ADDENDUM No. 3

**ORG #207 – San Jacinto Elementary School - Renovation
ORG #273 – Pleasant Grove Elementary School – Renovation**

DALLAS INDEPENDENT SCHOOL DISTRICT

11/01/2024

PARTIAL SECURITY AND SYSTEMS PLAN FIRST FLOOR AREA 'B1' AND 'B2'

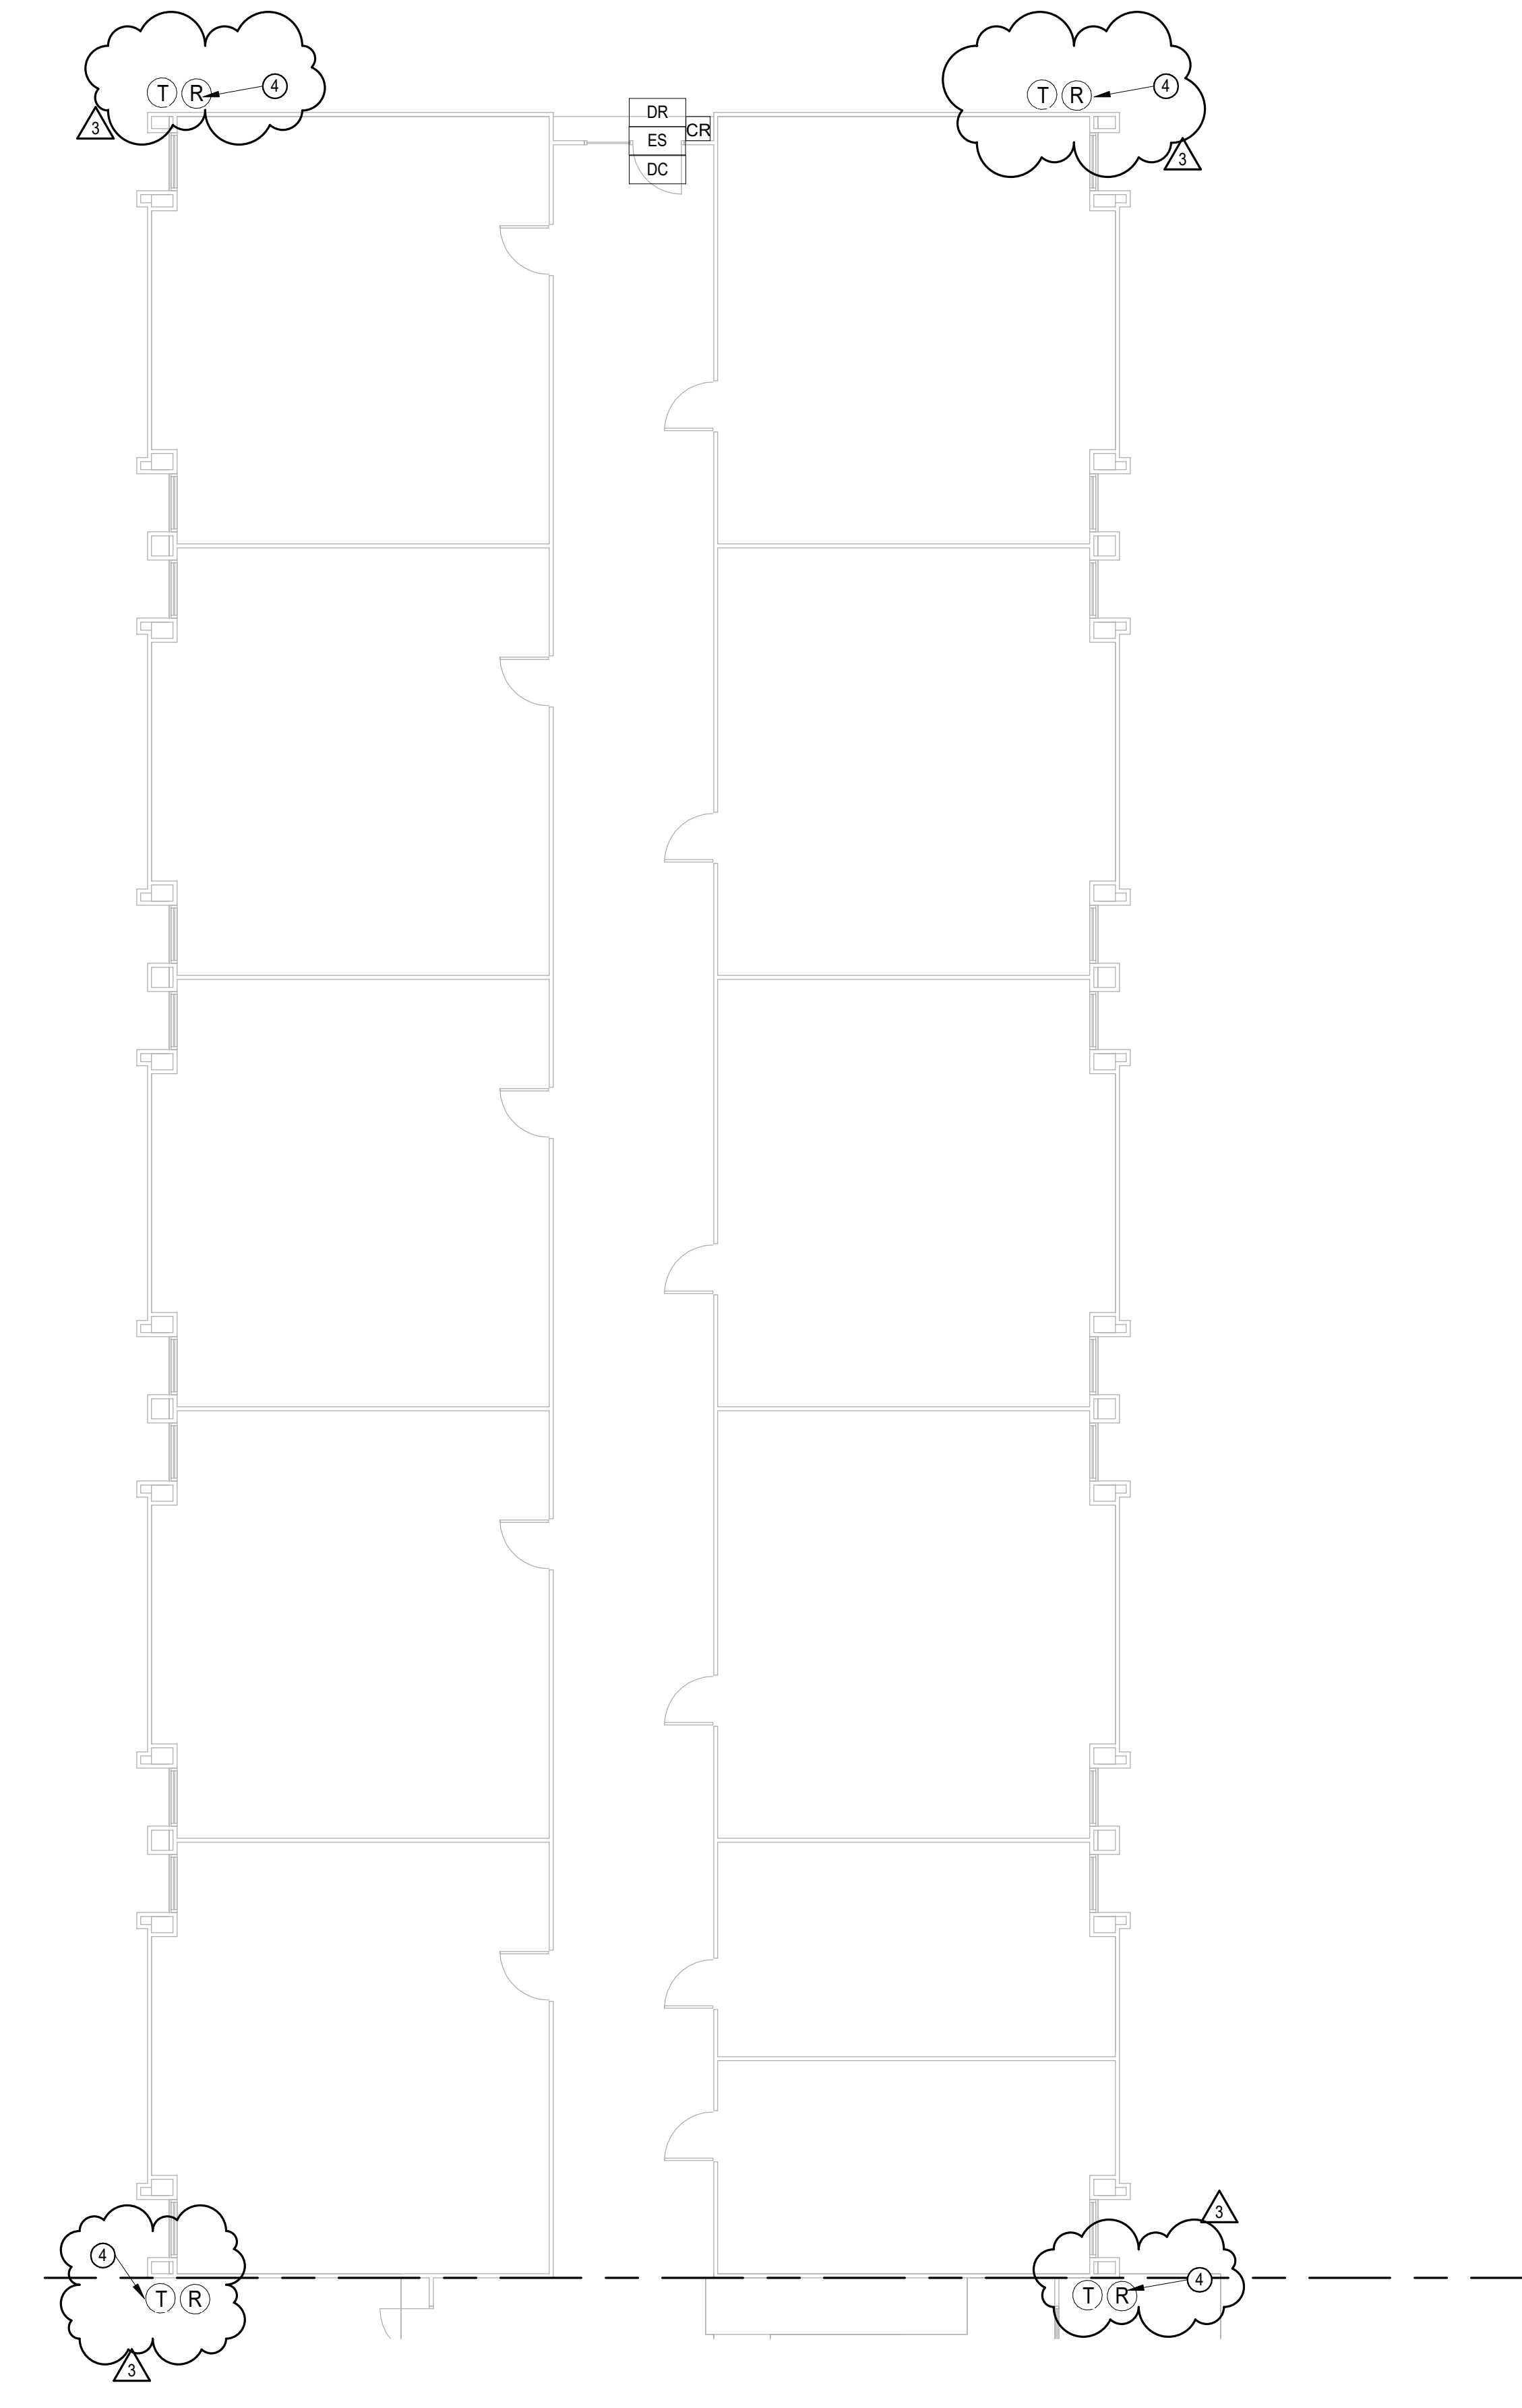
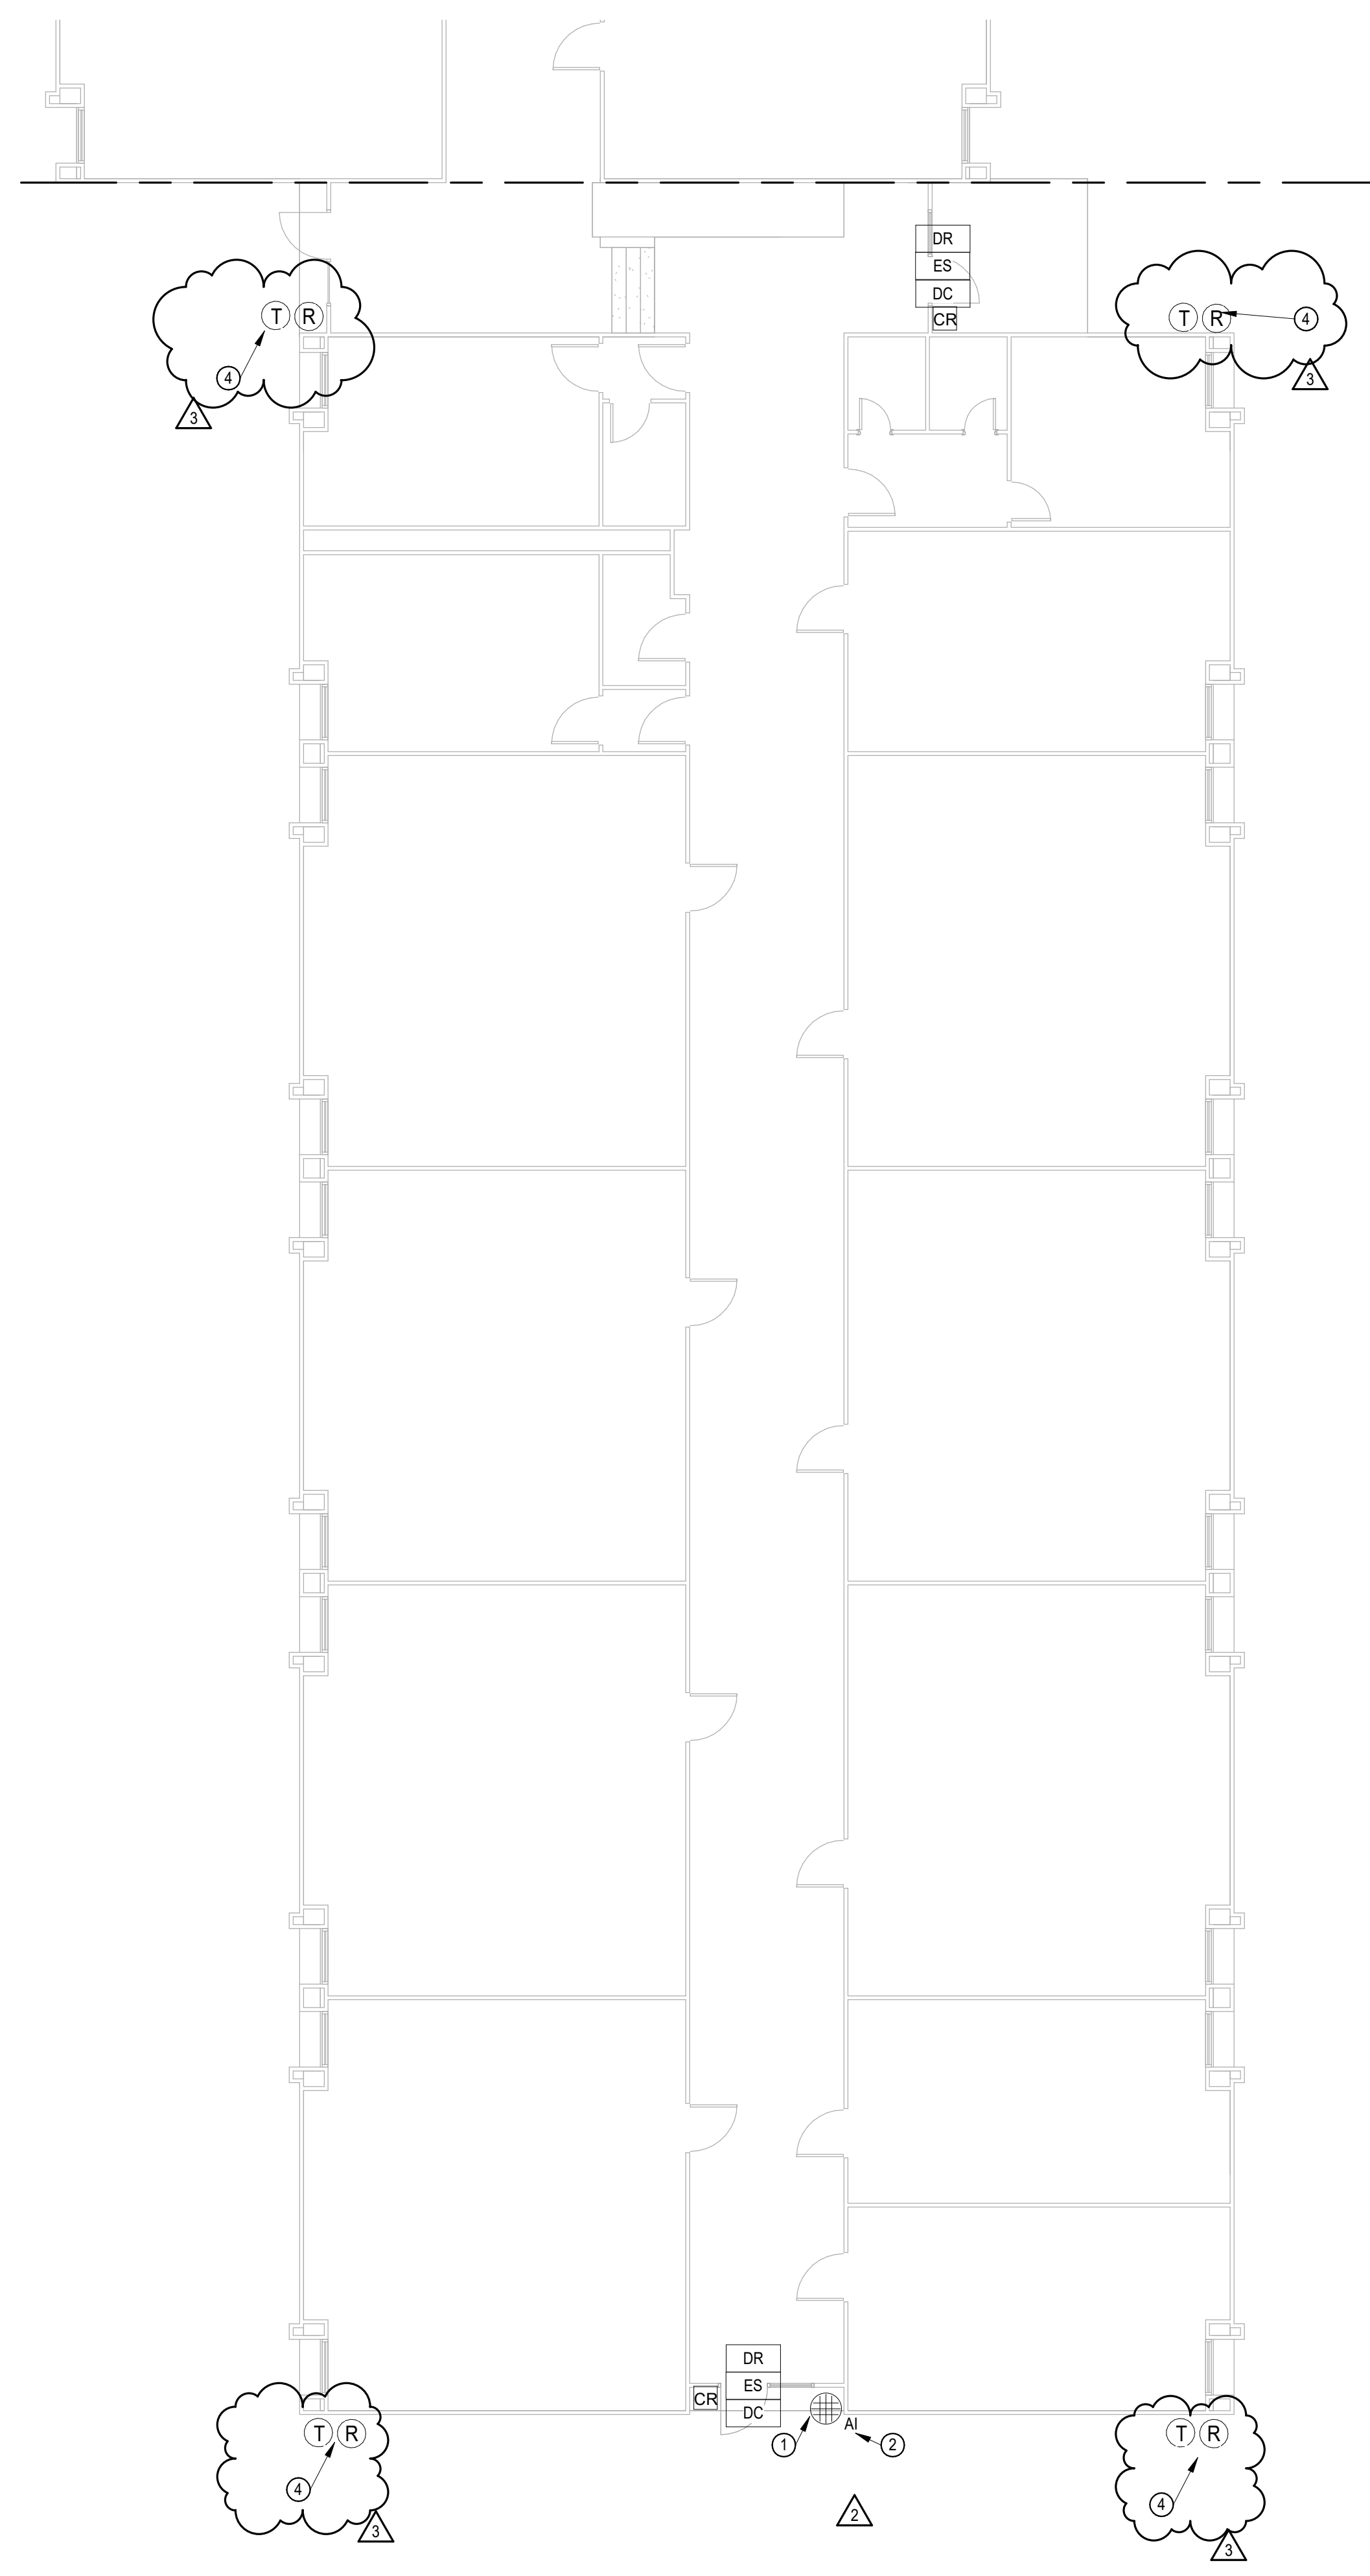
- Revised note by symbol 1 as indicated.
- Replace sheet with the revised attached TS2.13.
 - Video intercoms with door release added to main building back entrance and building B entrance.

- Pathway notes added.
 - Exterior 360-degree camera location added.
 - New motion beam detector locations and new panel
- Replace sheet with the revised attached M1.33.

1. VIDEO INTERCOM WITH REMOTE RELEASE.
2. PROVIDE 2" C FROM RECEPTION 104 TO B BUILDING VIDEO INTERCOM. RUN CONDUIT BELOW EXISTING WALKWAY ROOF. COORDINATE EXACT CONDUIT SIZE WITH DISD SECURITY CONSULTANT.
3. PROVIDE 2" C FROM ADMINISTRATION OFFICE TO AI PHONE LOCATION. COORDINATE EXACT CONDUIT SIZE WITH DISD SECURITY CONSULTANT.
4. REPLACE EXISTING EXTERIOR LONG RANGE BEAM DETECTORS WITH A NEW OPTED MODEL AA-20080 PLUS LONG RANGE DETECTORS MOUNTED ON NEW FABRICATED POWDER COATED BRACKETS EXTENDED FROM EXTERIOR WALL. DO NOT PENETRATE ROOF. PAINT ALL EXPOSED PARTS. CONNECT TO NEW NAPCO GEMINI P-9800 PANEL. REFER TO SHEET 71E3.01 FOR BRACKET DETAILS.

PROVIDE NEW NAPCO GEMINI GEM-P9800 FOR BUILDING B. CONNECT ALL EXISTING MOTION DETECTION DEVICES TO THIS NEW PANEL. EXTEND EXISTING CABLES AND RACEWAYS AS NEEDED. SITE VERIFY ALL EXISTING MOTION DETECTION DEVICES ARE COMPATIBLE WITH THE NEW P9800 PANEL.
